## 7.6 All Other Instrumentation Systems Required for Safety

The information in this section of the reference ABWR DCD, including all subsections, tables, and figures, is incorporated by reference with the following departures and supplements.

Figure 7.6-4a Basic Configuration of a Typical Neutron Monitoring System Division

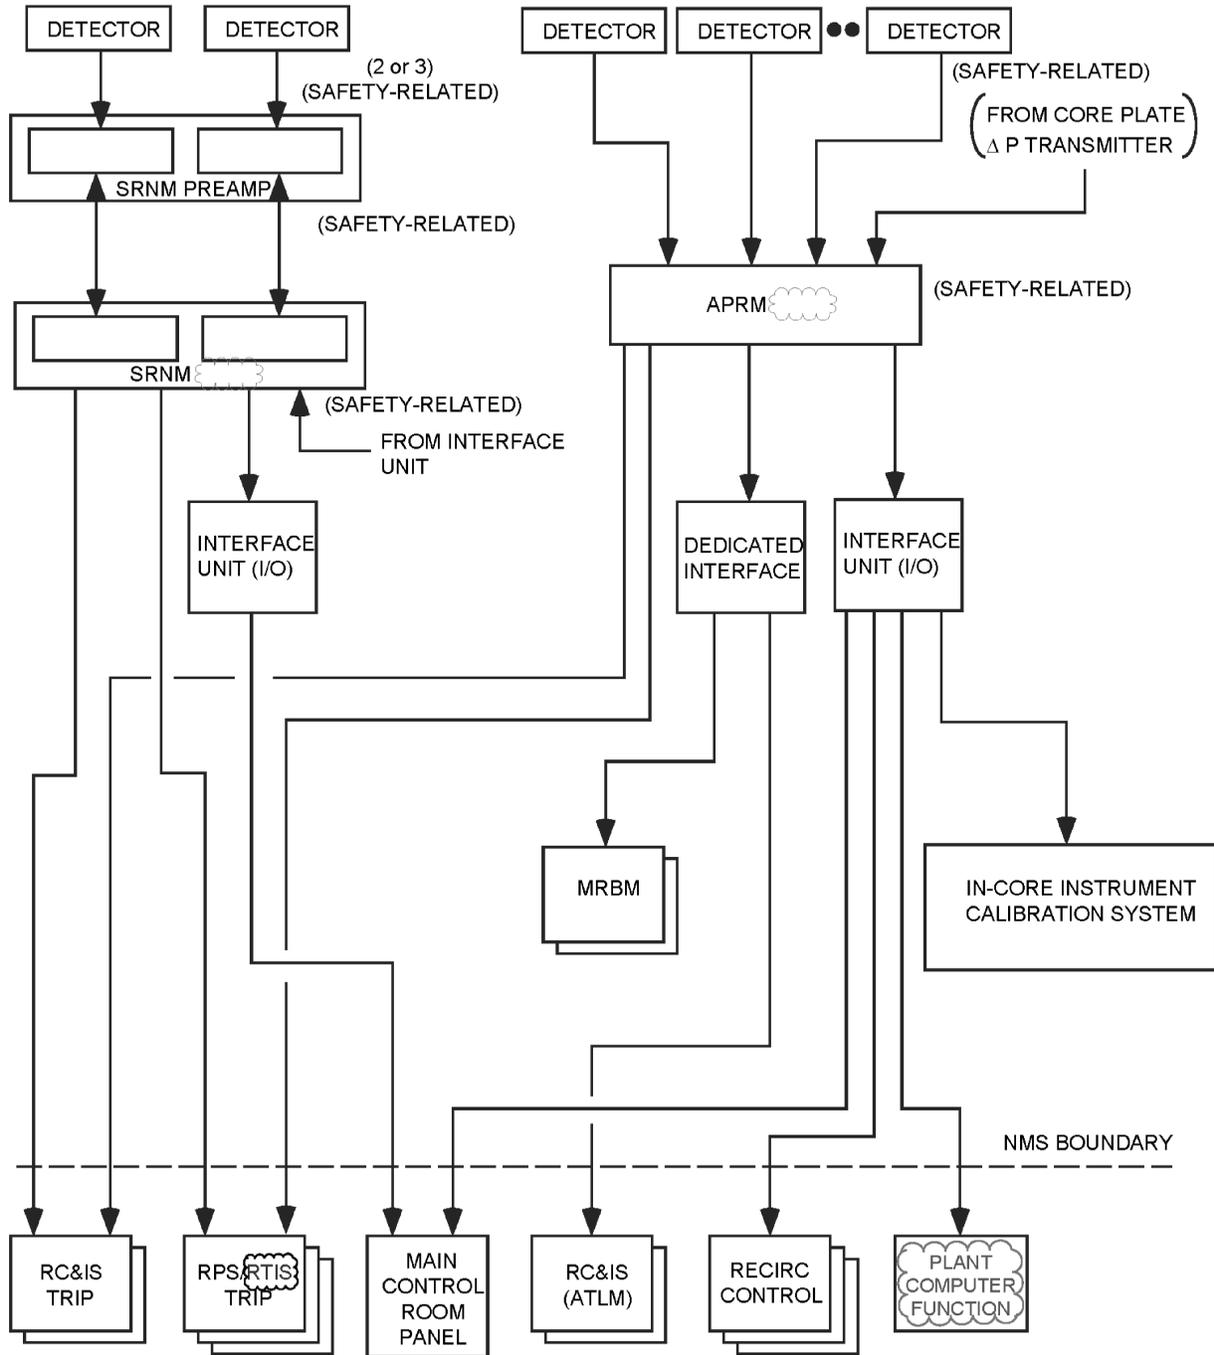
STD DEP T1 3.4-1 (Table 7.6-5 and Figures 7.6-1, 7.6-2, 7.6-4a)

*The purpose of the Neutron Monitoring System (NMS) is to monitor power generation and, for the safety function part of the NMS, to provide trip signals to the Reactor Protection System (RPS) to initiate reactor scram under excessive neutron flux (and power) increase condition (high level) or neutron flux fast rising (short period) condition. The NMS also provides power information of operation and control of the reactor to the Plant Process Computer System (PCS) Functions (PCF) and the rod block monitor. A block diagram showing a typical NMS division is shown in Figure 7.6-4a. The operating ranges of the various detectors are shown in Figure 7.6-4b.*

Figure 7.6-9 Instrumentation Location Definition for the Suppression Pool Temperature Monitoring System

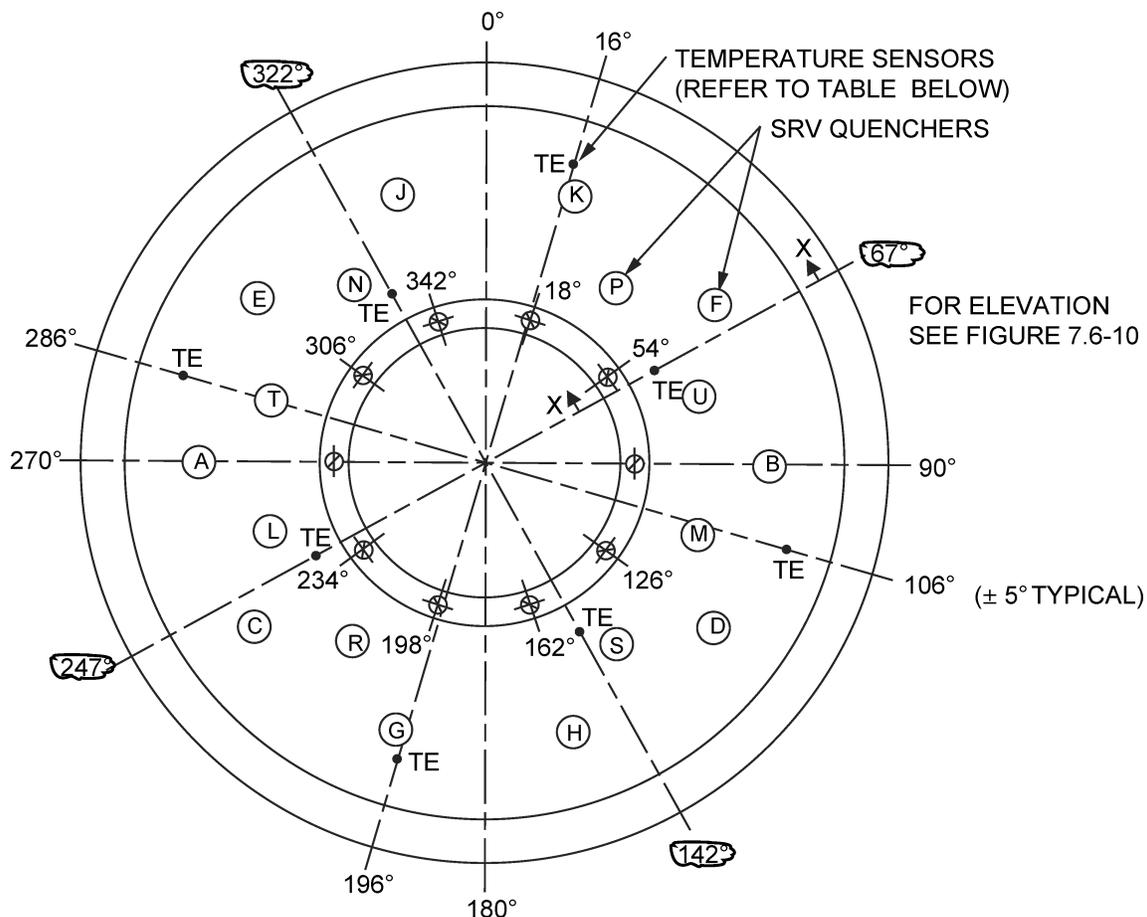
STD DEP 7.6-3 (Figures 7.6-9, 7.6-11)

The SPTM System configuration is shown in Figures 7.6-9 and 7.6-10. There are eight temperature circumferential sensor locations (Figure 7.6-9), which are chosen based upon the following considerations:

- (2) Each SRV discharge line quencher is in direct sight of two sets of temperature sensors within 9 meters.

Figure 7.6-14 OPRM Logic

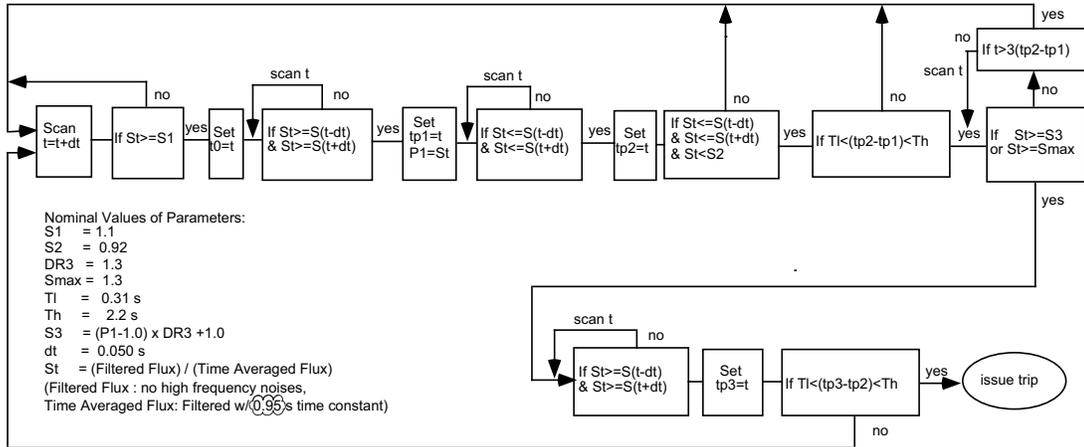
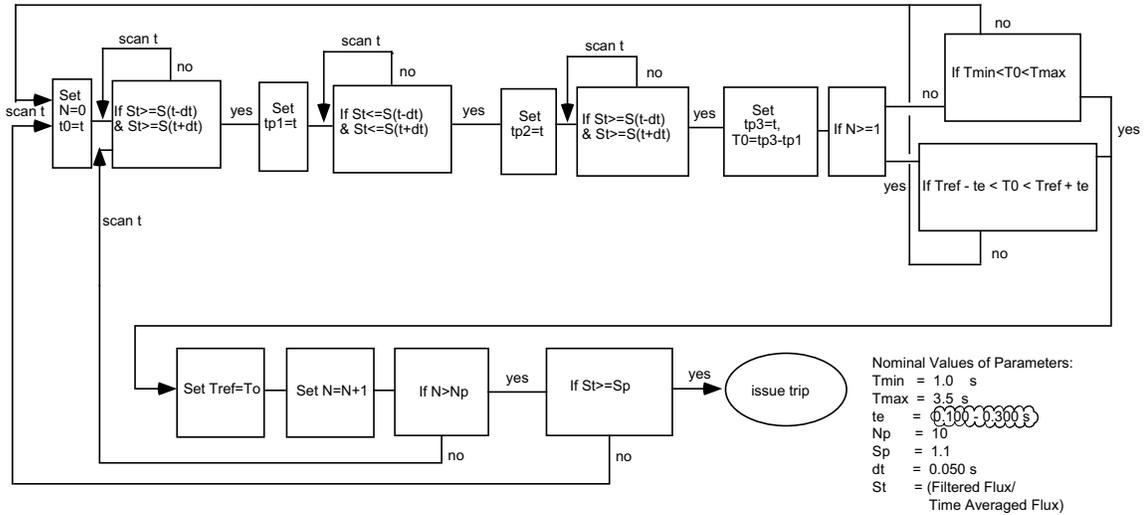
STD DEP 7.6-1 (Table 7.6-2 and Figures 7.6-2, 7.6-14)

*For the OPRM trip function, the response signal of any one OPRM cell that satisfies the conditions and criteria of the trip algorithm will cause a trip of the associated OPRM channel. Figure 7.6-14 illustrates the trip algorithm logic. ~~The OPRM trip function does not have its own inoperative trip for insufficient number of total LPRM inputs in the channel. It follows the APRM's inoperative trip of insufficient number of LPRMs.~~ The OPRM function has its own inoperative trip when the channel has less than the required minimum operable cells, when there is an OPRM self-diagnostic fault, when the APRM instrument watchdog timer has timed out, or if there is a loss of power to the APRM instrument.*

$T_{\min}=1$  s,  $T_{\max}=3.5$  s,  $\pm t_{\text{error}}=0.15$  s **[0.100 - 0.300s]**,  $N_P=10$ .  
(For details see Figure 7.6-14).
